**[Issue No.]** GOT-A-0059-A

**[Title]** CF Card Connector Change

**[Relevant Models]** GOT1000 Series (GT1655, GT1555, GT1550, GT1155-Q□BDQ, GT1150-QLBDQ, GT15-CFCD)

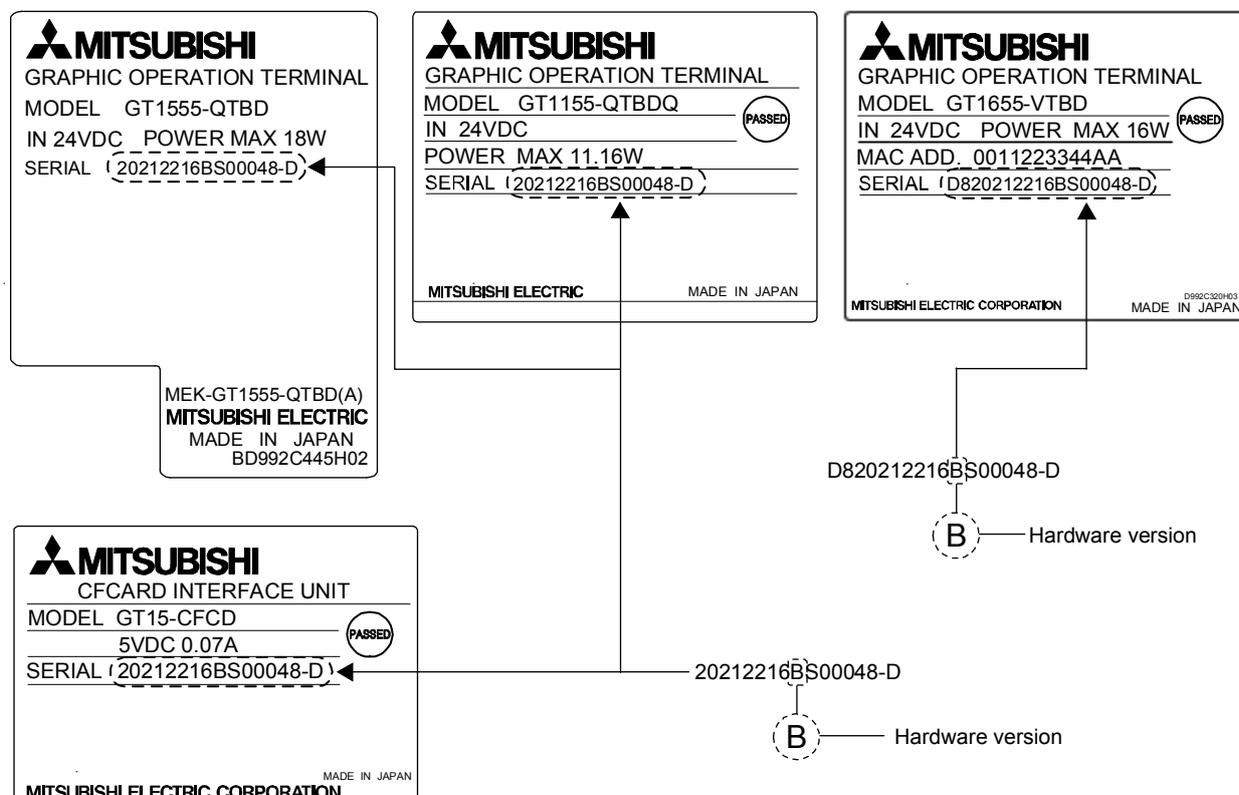
The following shows how to check the hardware version.

### ■ Indication on rating plate (GOT rear face)
